ADDENDUM 4

DATE: November 30, 2016
 PROJECT: MSB First Floor Infill LRC 3 & 4
 RFP NO: 744-R1705
 OWNER: The University of Texas Health Science Center at Houston
 TO: Prospective Proposers

This Addendum forms part of and modifies Proposal Documents dated, October 19, 2016, with amendments and additions noted below.

**Demolition Reflected
Ceiling Plan - Ground Level**

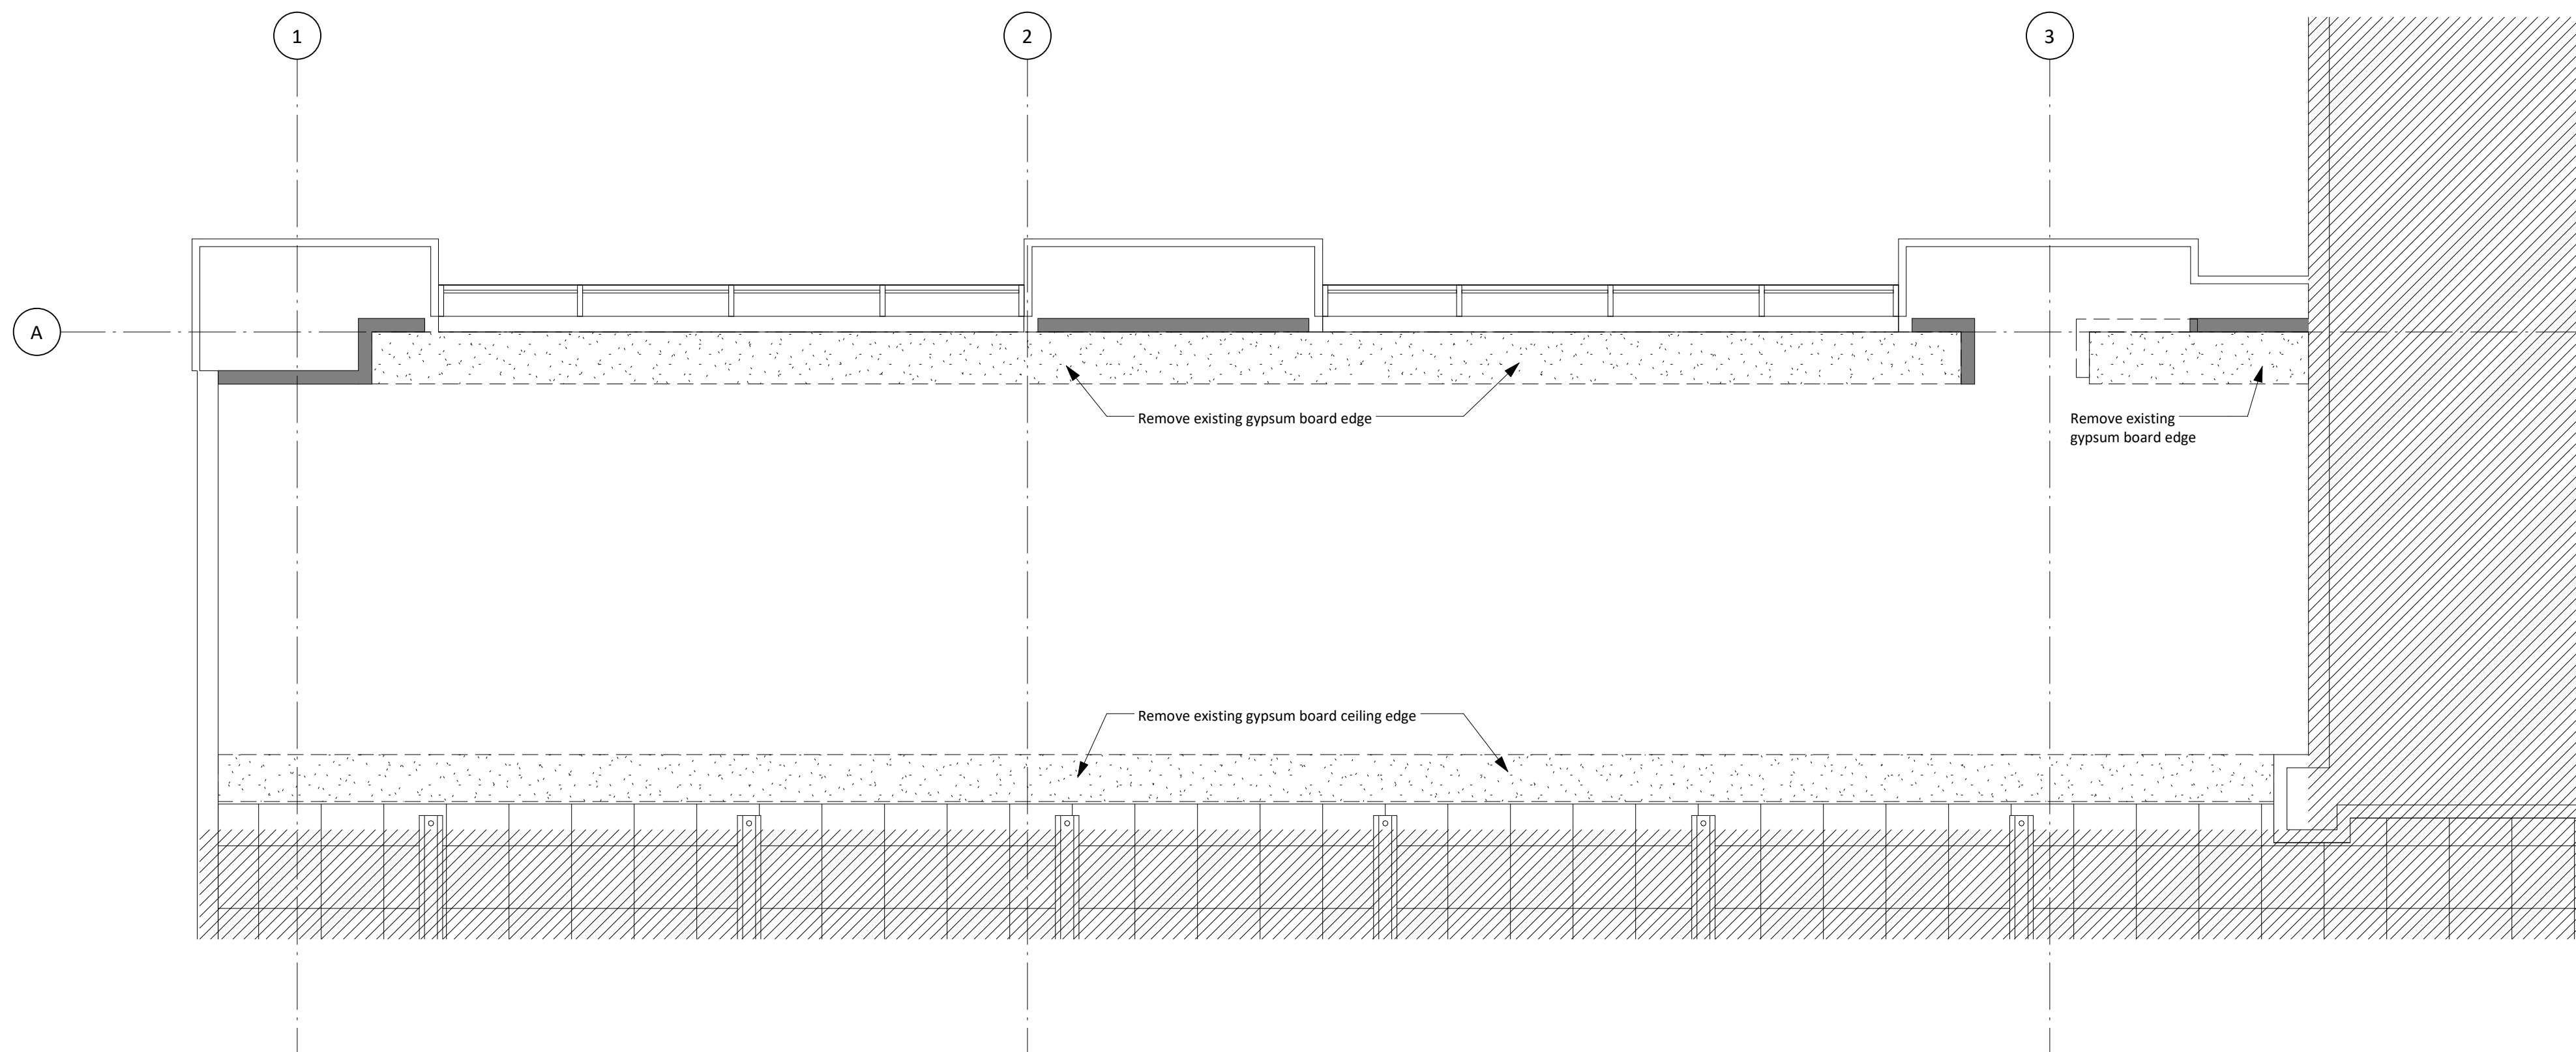
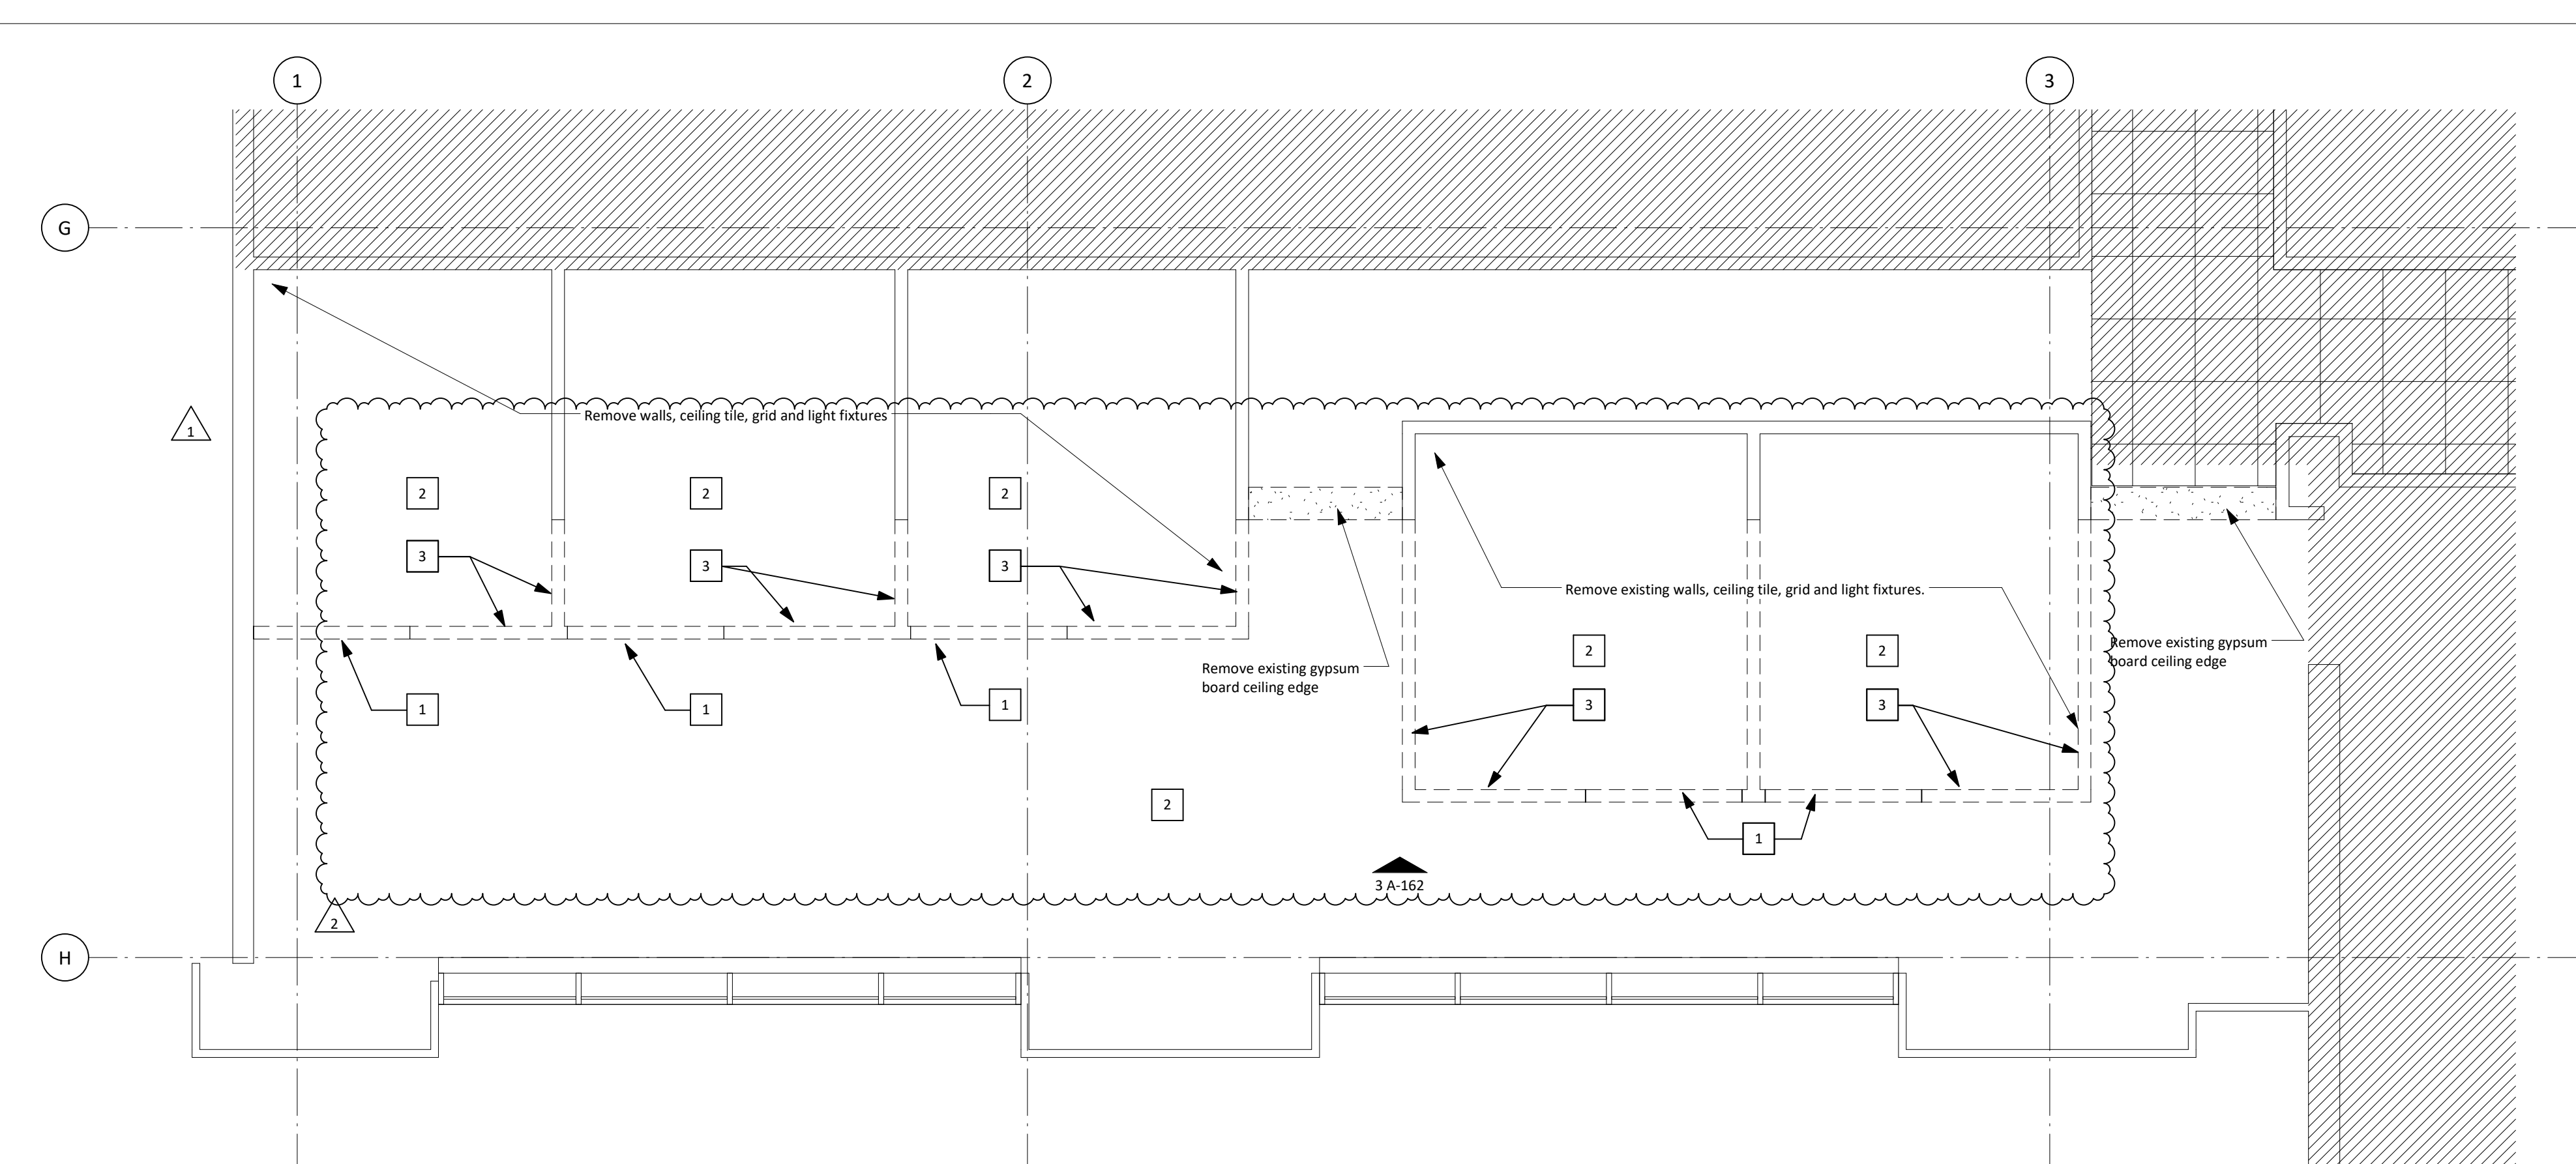
3. Drawing A-161 Detail 1 completely demolishes the ground floor group study rooms and is not shown to be rebuilt after completion of construction. Is this the design intent? If not, please provide a renovation plan detailing the build back.
Walls being demolished on the ground floor are to be built back up; ceiling grid removed at ground level needs to be reinstalled, doors, frame and hardware are to be removed and reinstalled. All floor finishes are to be preserved; if damaged or removed GC to reinstall to match the existing finishes. Additional information provided in Addendum 4 drawings below.

Room Finish Type Schedule 2

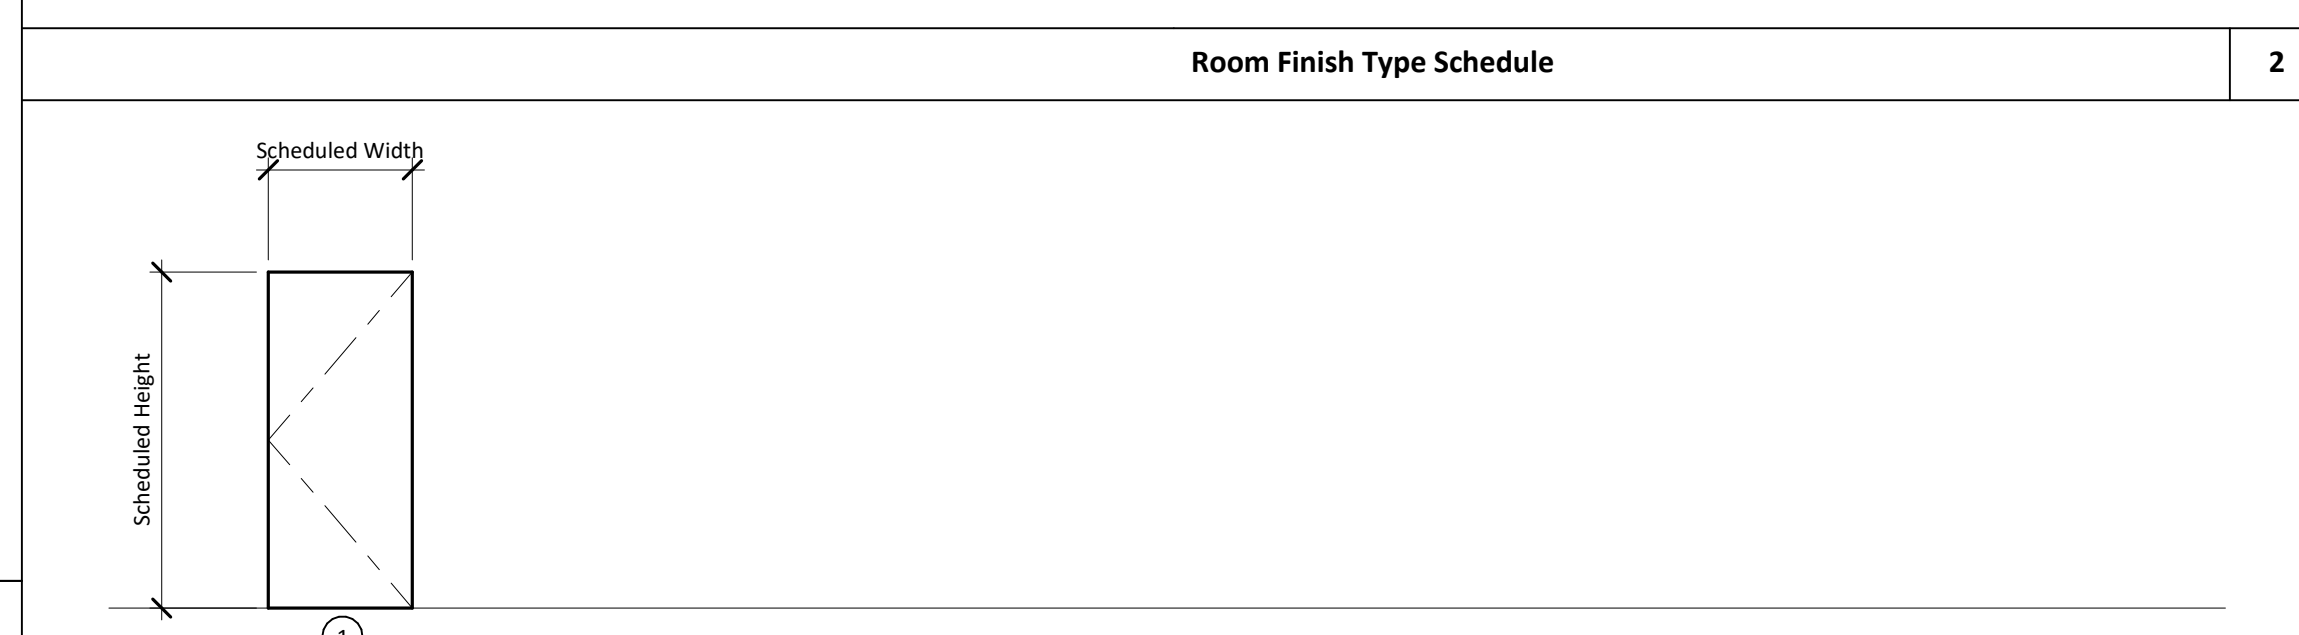
1. Please clarify the design intent for F13 as noted in ADD 03
 - a. Room Finish Schedule, sheet A-540 calls out material as CPT-2

- b. Finish Material Schedule, sheet A-540 only calls out a change to CPT-1 & VCT-1

CPT2 (9223 Hops) will not be used at Level 1; it will be omitted.

CPT2 will be omitted.

Door Type Schedule 1

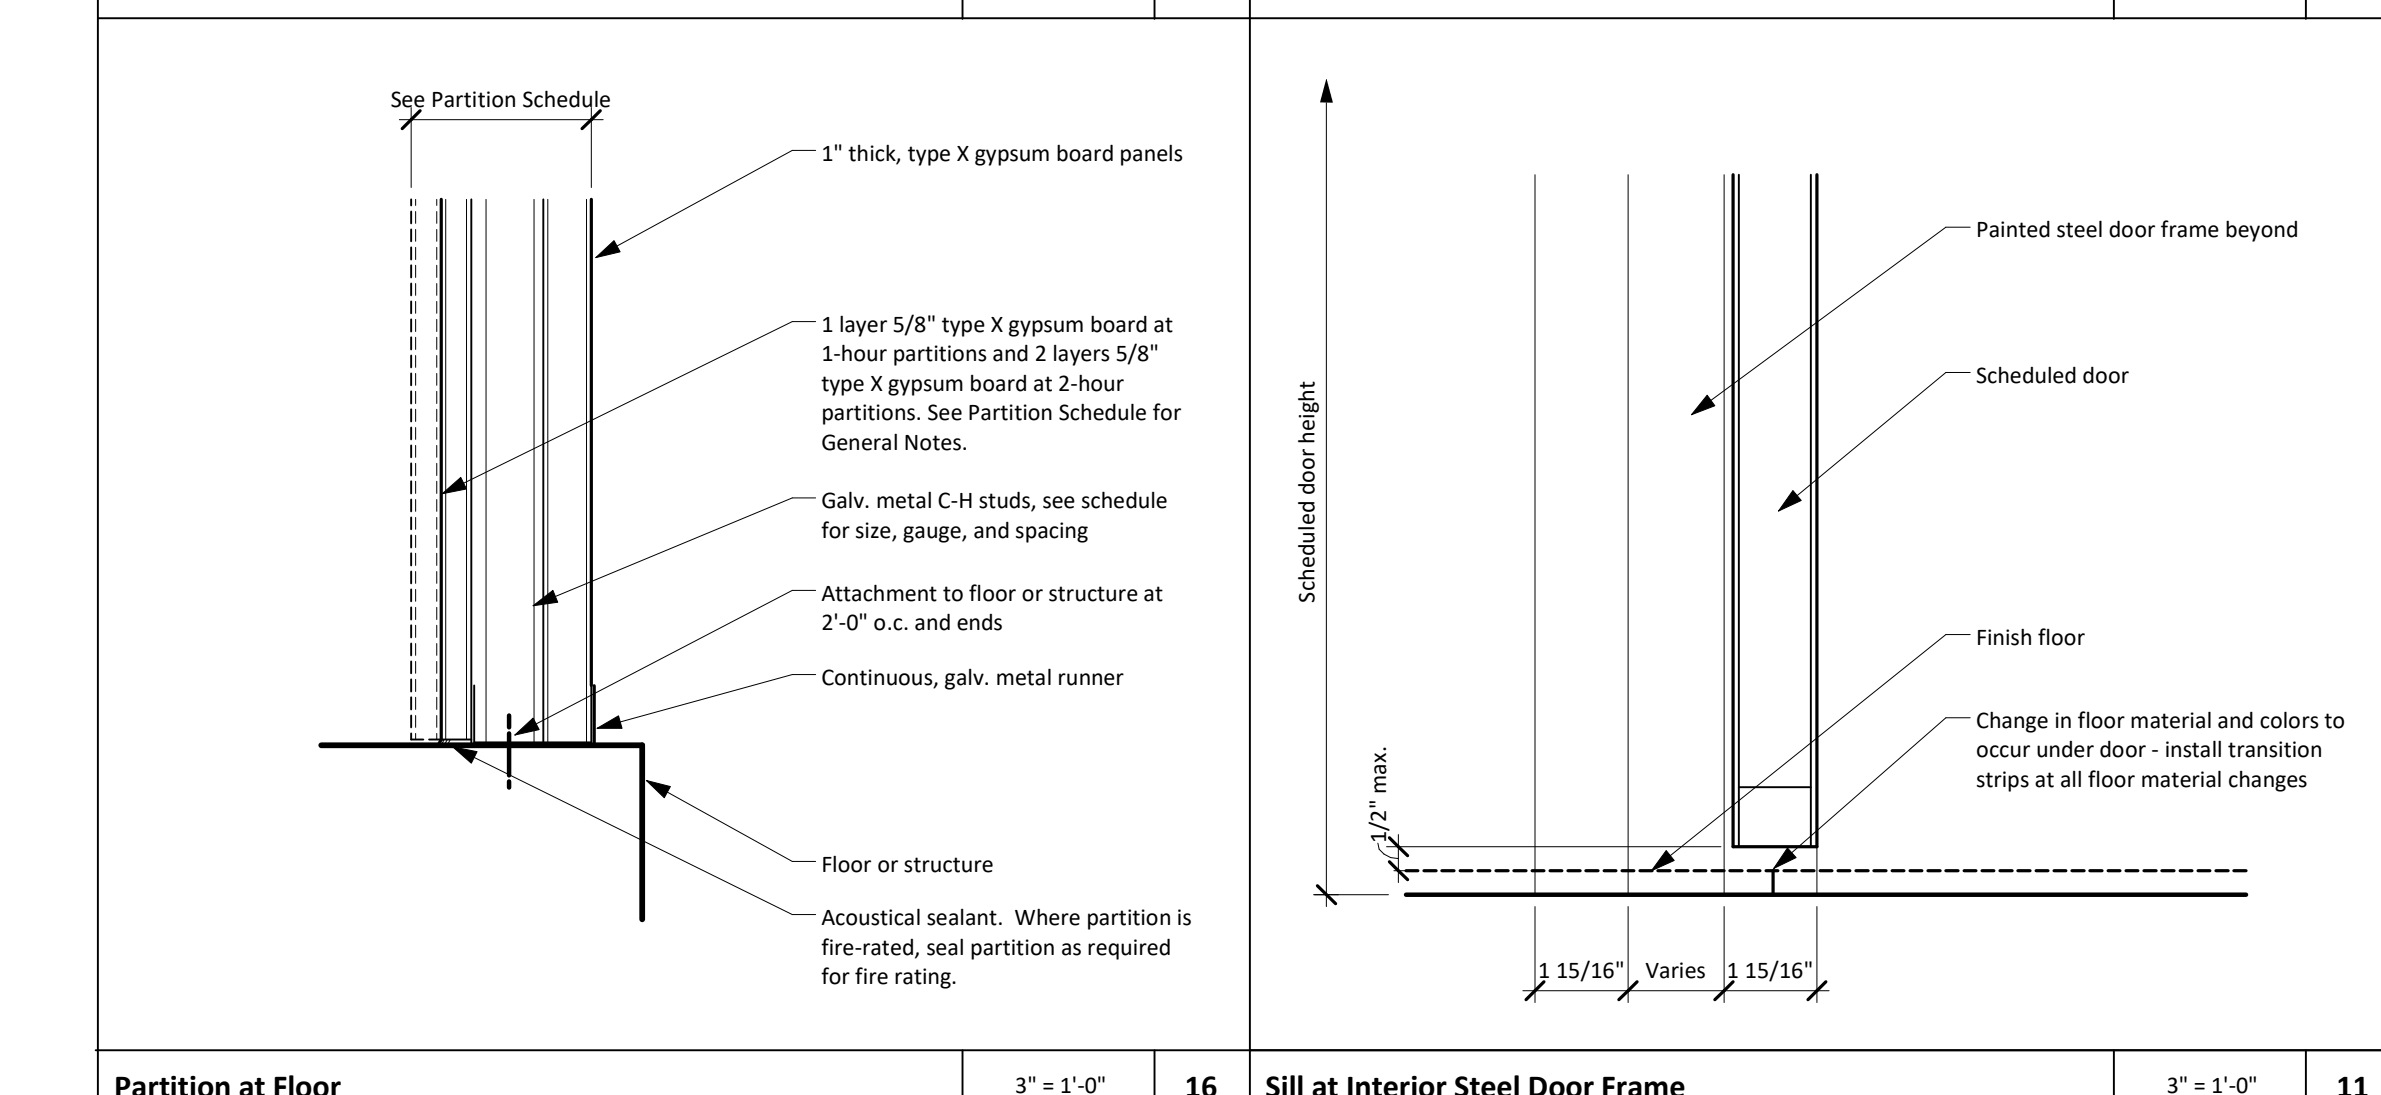
4. Please confirm the door pattern/line and color shown on Drawing A-540 are to be installed on both ground floor and 1st floor.
Doors on ground floor are to be existing. No new doors at this level.
